## Product Change Notification

### PCN-PCC-7815-2022

Business Unit	Product Line Code	Type of Change	Action	Date of Issue
PCC - PCB Connectors	AAC	Product Change Notification	Notify Distributors and Field	3/28/2022

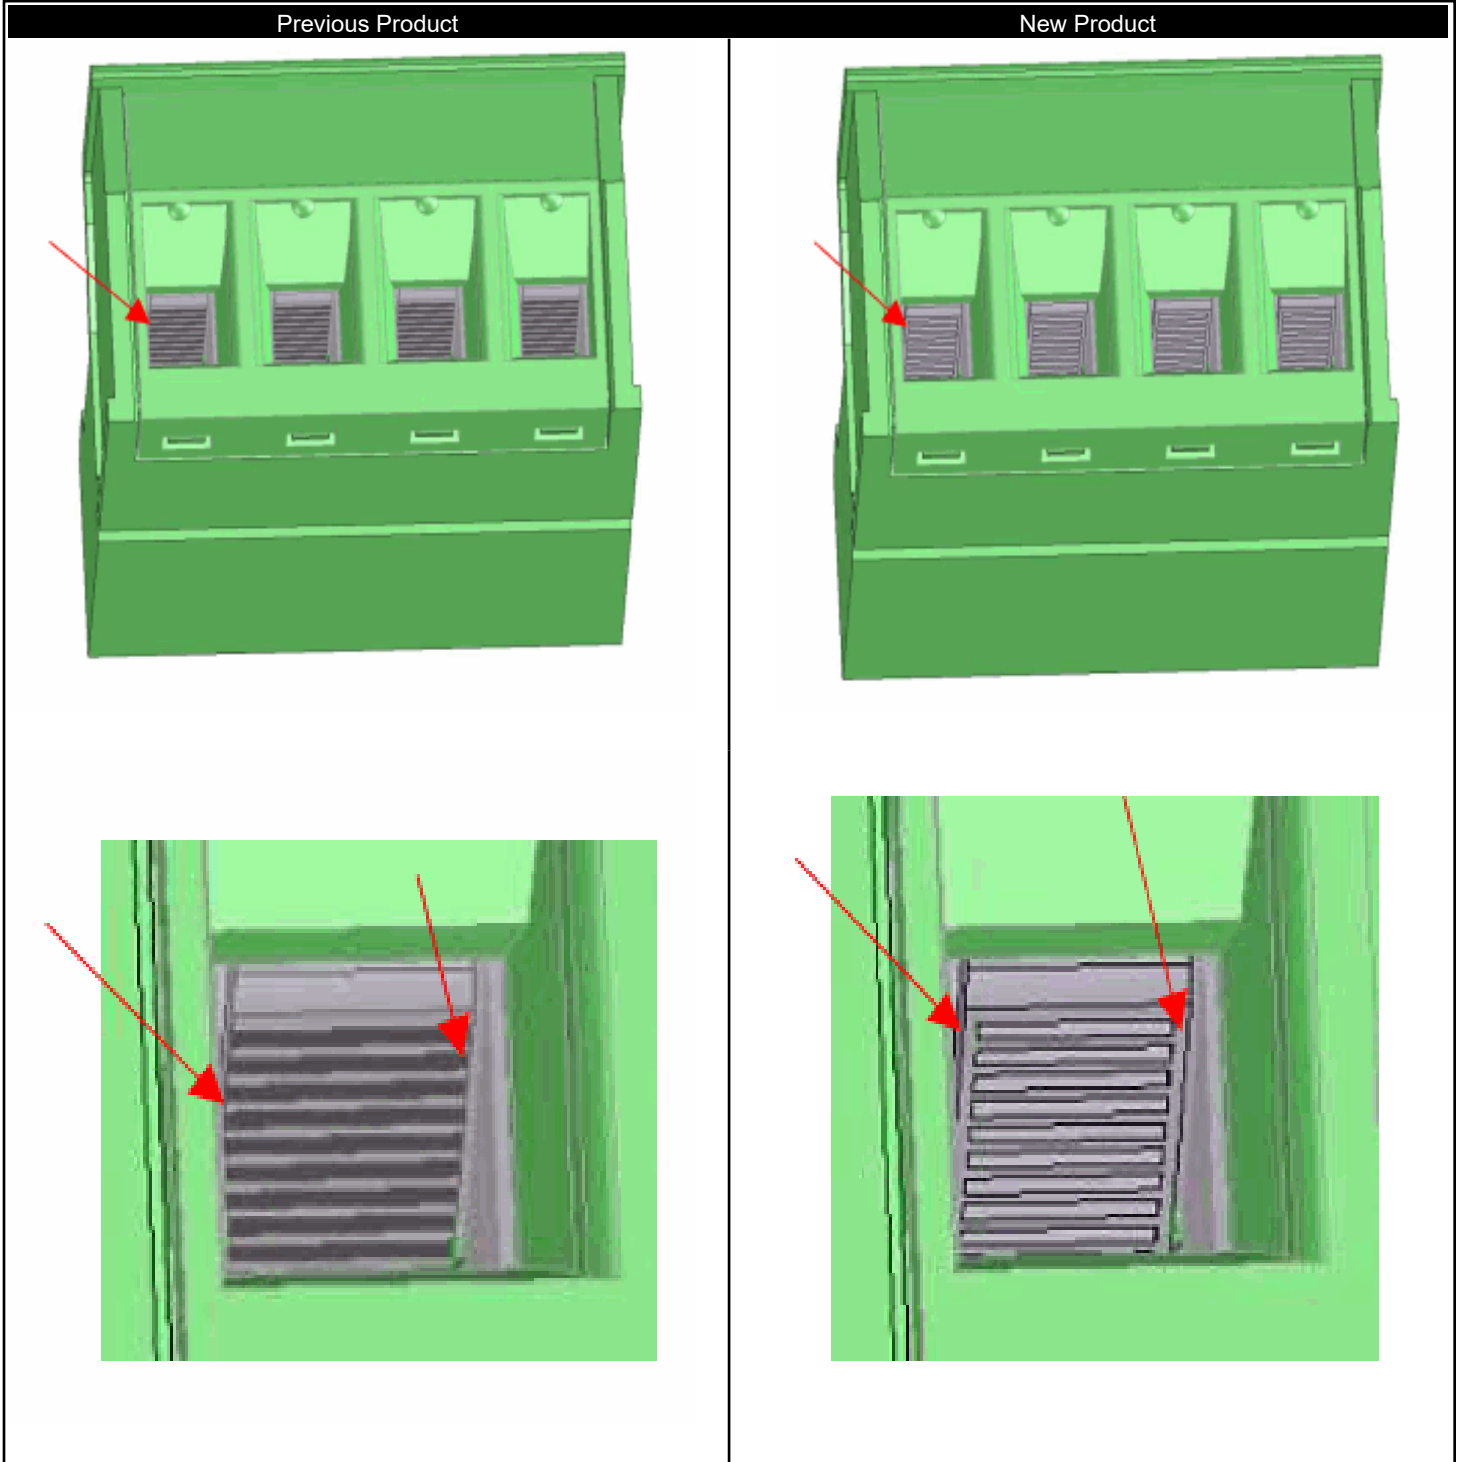
Description for Product Change Notification
In order to optimize the manufacturing processes for parts within the (G)IC 2,5/...-ST(G)(F), DFK-MSTB 2,5/...-STF and (U)MSTBHK 2,5 series, the current bars will have a thin, continuous bridge on the outer edges without fluting in the area of the conductor connection. A visual comparison of old/new is provided in the attachment. The change has no effect on the technical properties of the item. The batch number will not be increased.
